Our Ref: BS:KL:239312s

RE: ADDITIONAL INFORMATION MP05-0083 SANDY BEACH - MOD 5

Reference is made to The Department's request for Additional Information with respect to MOD 5 of the Sandy Beach subdivision development.

Figure 1: Conceptual Layout of Proposed Water Management Structures.

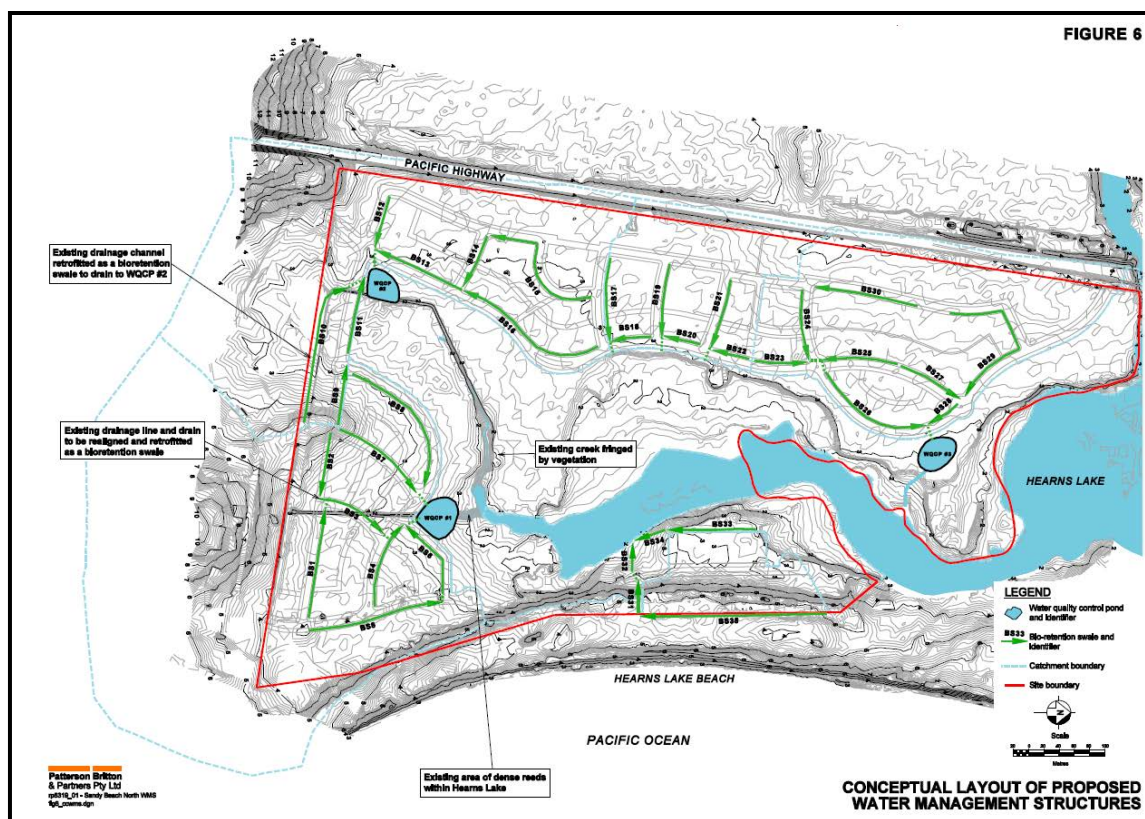
Figure 6 of the Patterson Britton & Partners Drainage report “Conceptual layout of proposed Water Management Structures” reproduced (below as **Figure 1**) shows the location of proposed swales and a water quality control pond located over the existing drainage line between stages 1 and 3 on the northern side of the development footprint.

The water quality control pond sits outside the nominated road reserve boundary. This facility, if constructed, would require removal of vegetation additional to what is proposed in the amended proposal. Design review indicates that the proposed swales within the road reserve have insufficient capacity to convey stormwater through the site. Further the cross section of the swale is not compatible with the proposed footway widths. We also have concern with the concept design for the proposed water quality control pond due to site levels.

The proposed drainage solution depicted in the ADW concept engineering drawings (**Appendix B**) has been designed to meet water quality control objectives of the Concept Approval. The proposed solution reduces the overall size and environmental impact of the water quality control pond from that proposed in the Patterson Britton Report by proposing several elongated bio-retention basins on the outside of the road formation. This strategy is documented in the report prepared by Advisian dated 10 May 2017 that has been prepared for the lodgement of a development application for Stages 1 and 3 subject to the 75W application being approved.

239312-VEG-001-A

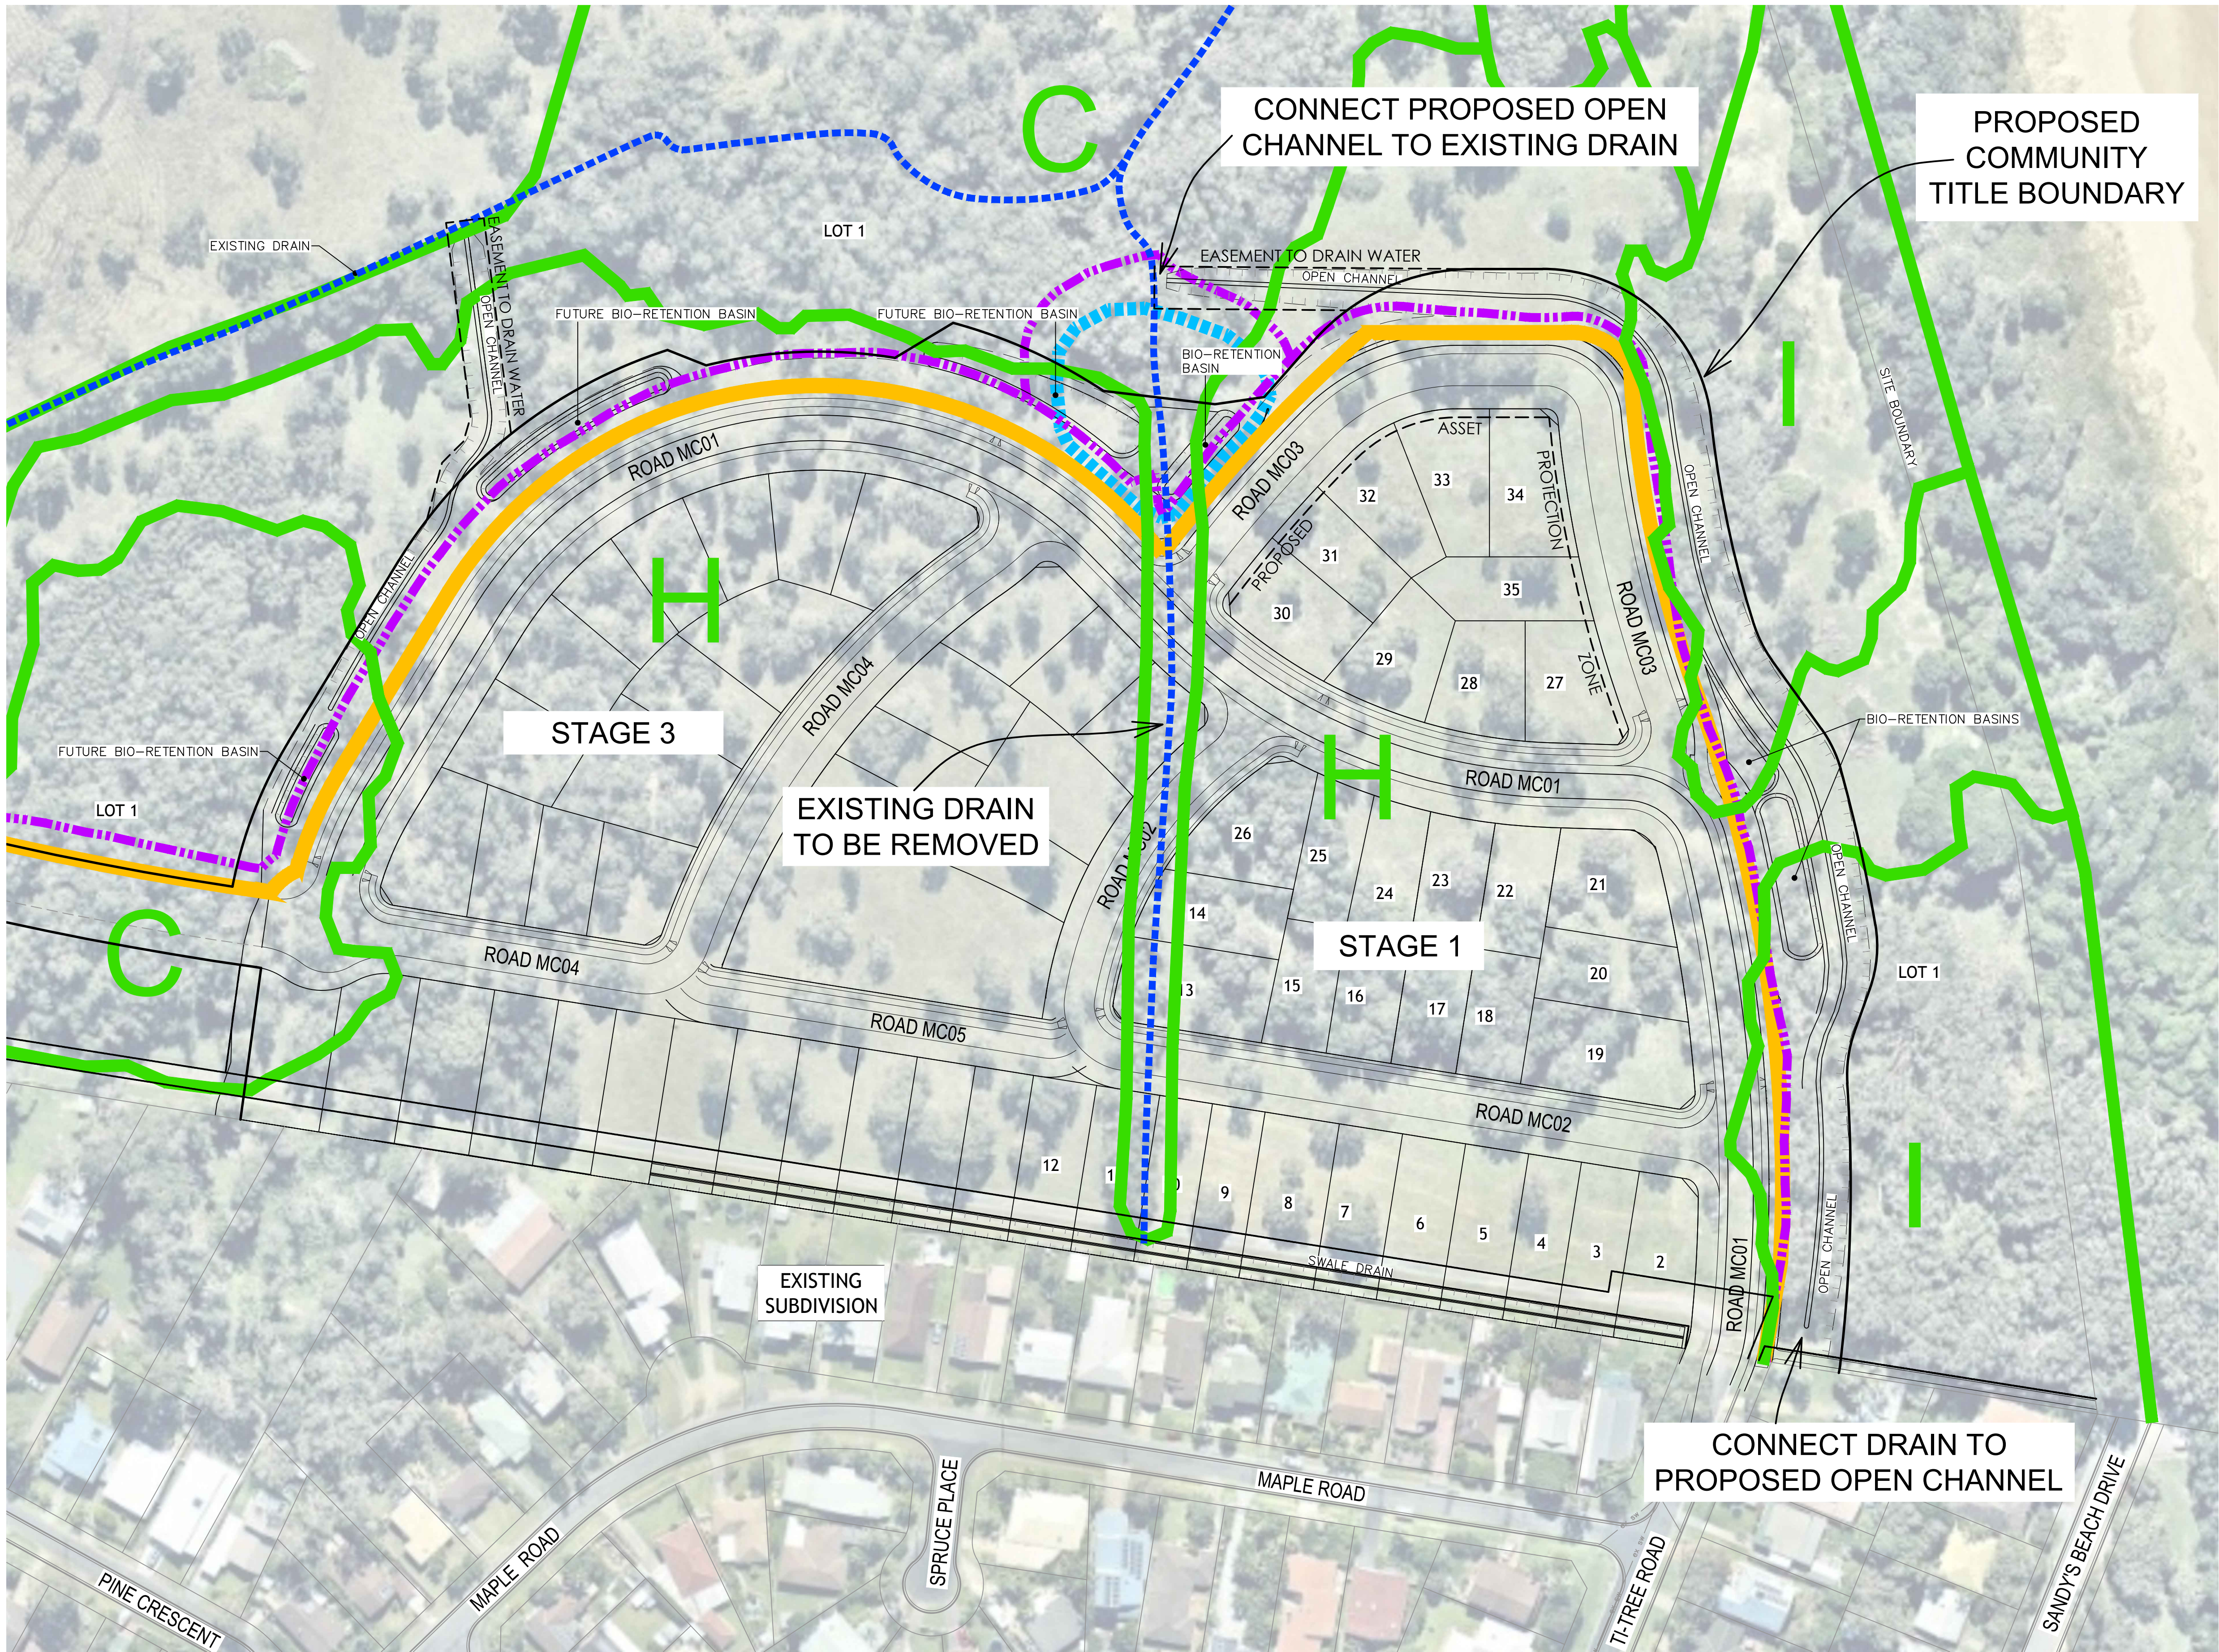
The plan attached as **Appendix A** shows the proposed development including the stormwater infrastructure for Stages 1 and 3 overlaid on an aerial photograph. It is proposed that the drainage infrastructure will predominantly be located within the future road reserve as indicated, and drainage easements will be provided across the community lot to existing watercourses that form a legal point of drainage connection.

The impact on swamp sclerophyll forest marked as Vegetation Type C on the overlay plan sourced from the Flora and Fauna report in the original application is considered to be less than the original proposal.

The open channel to the east of Tee- Tri Road in the current proposal is consistent with the swale BS5, from the Patterson Britten Report. Some additional area is required for the bio retention basin however this has been located in a generally clear area to minimise any impact. The area impacted by the open channel will be landscaped mitigating vegetation loss.

TYPICAL OPEN CHANNEL DETAIL
N.T.S.

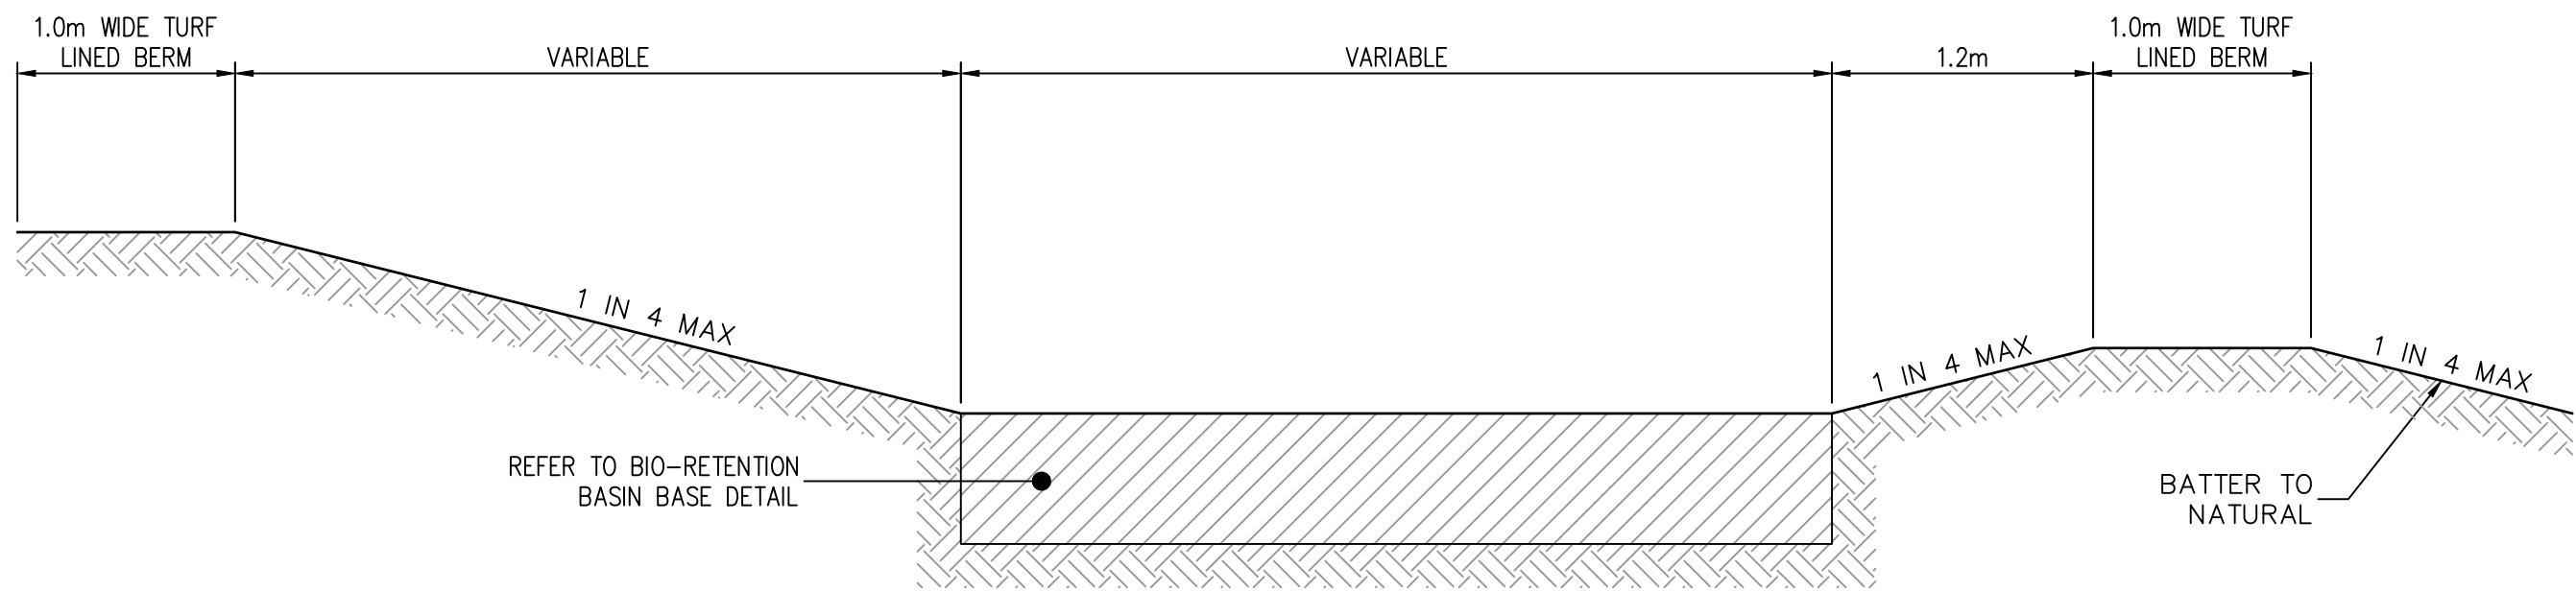
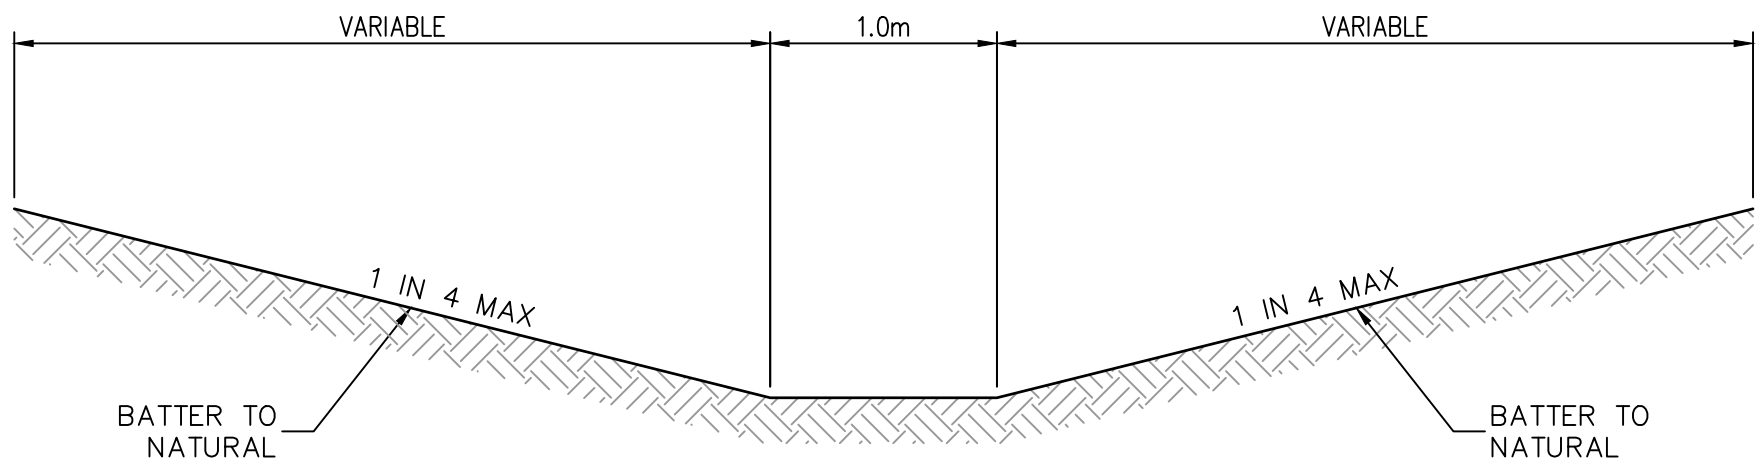
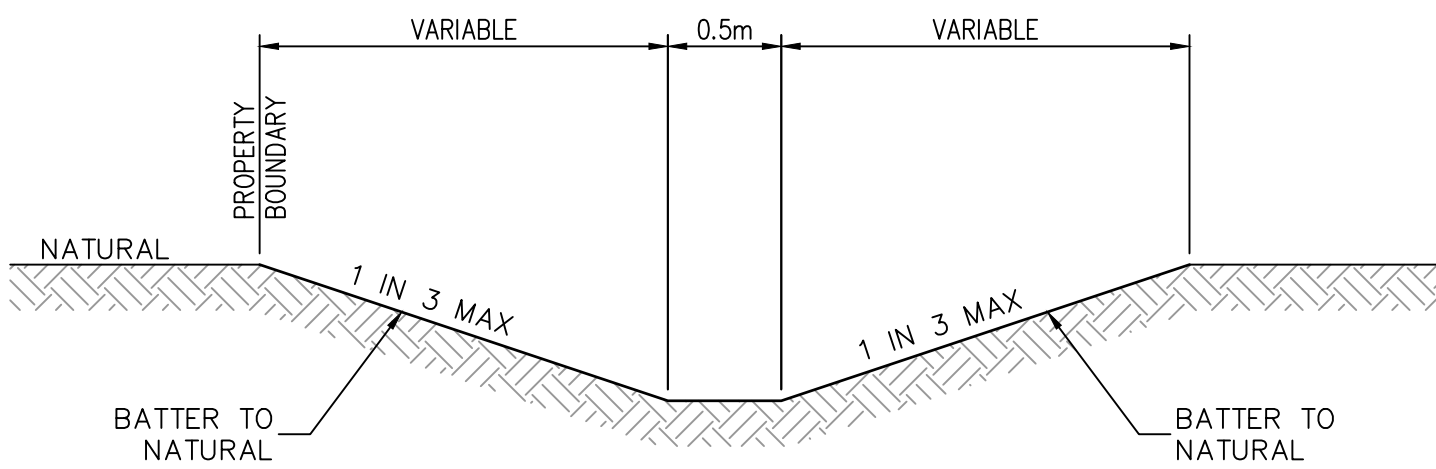
Council has advised through you, of concerns about the future maintenance of the new swale drain (open channel) and impact of the modified stormwater system on the development site and existing properties in the area.

The open channel as detailed in the engineering plans will be constructed with a 1.0 metre wide base and 1 in 4 sides that will be plated with native grasses with occasional tree planting and require minimal maintenance. We note the Patterson Britton drainage strategy included a swale (BS5) on the outside of the extension of Ti -Tree Road as indicated in **Figure 1** below. With respect to flood impacts the development is downstream of existing development and drainage from the existing development is being collected and managed through the site. Detention will be provided within proposed drainage facilities to mitigate impacts.
